Technical Service Bulletin: tsb090024	Released Date: 07-Apr-2009
Air Leak Past Compressor Inlet Hose Coupling At Cylinder Head

Figure 1: Interference between coupling and cylinder head.

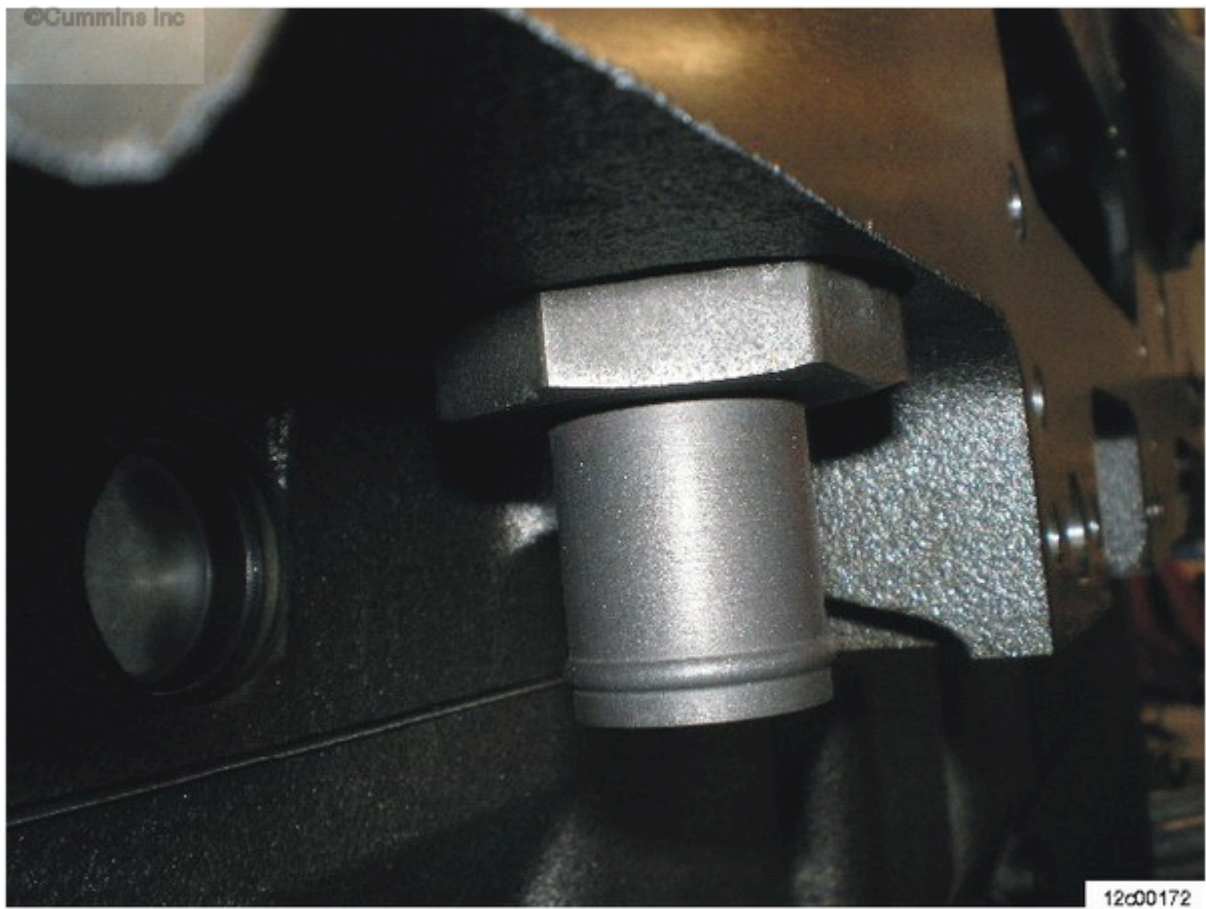
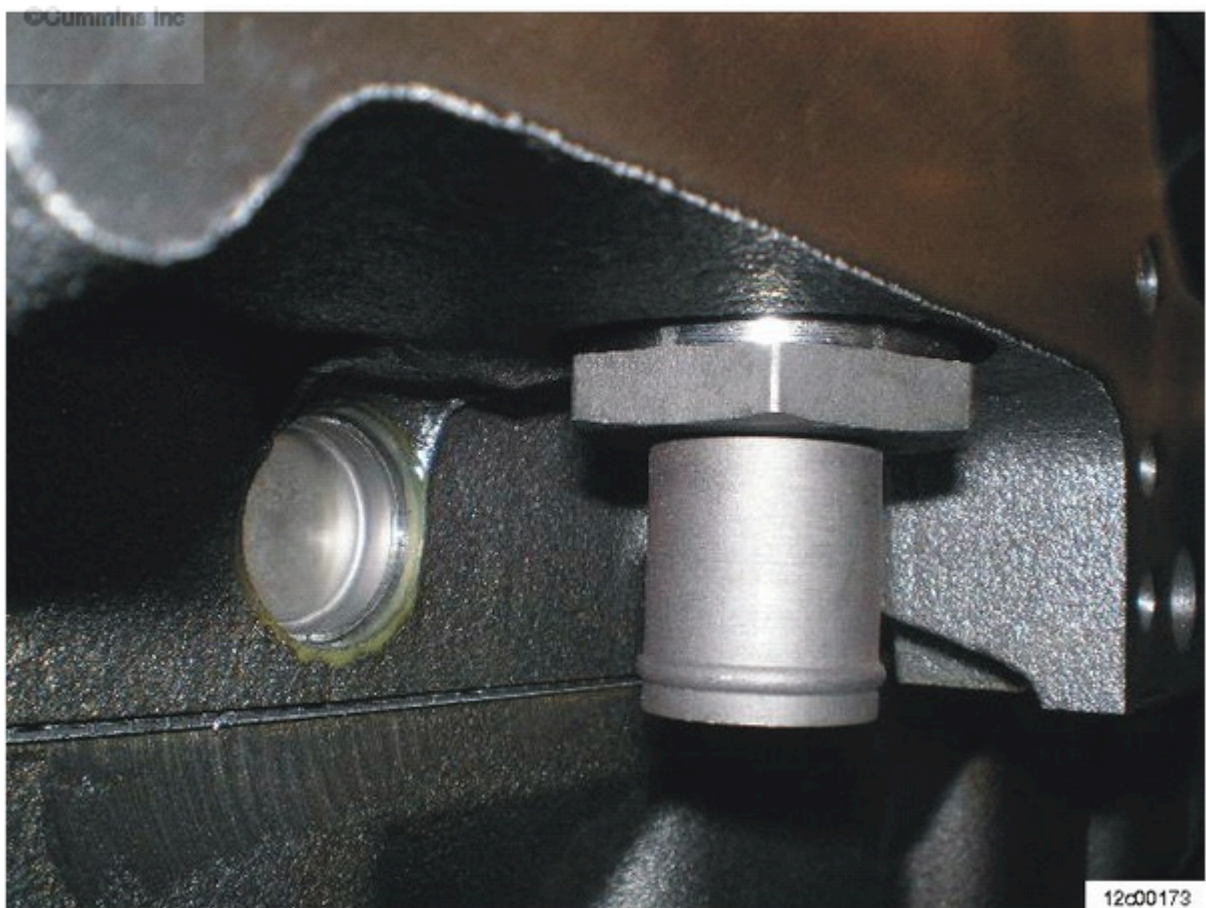
This Early Field Notification informs the field that some ISX cylinder heads have a spot face at the compressor inlet hose coupling that is smaller than the fitting hex diameter and could possibly result in an air leak at the joint.

Confirm there is air leakage at the compressor inlet hose coupling due to interference between the coupling and the cast surface of the cylinder head.

The machined spot face is smaller than fitting diameter on some cylinder heads.

Modify the compressor inlet hose coupling to eliminate interference. Use a lathe to remove up to 3 mm [0.118 in] of material from the underside of the wrench flats to avoid interference and allow the coupling to seat in the machined spot face of the cylinder head.
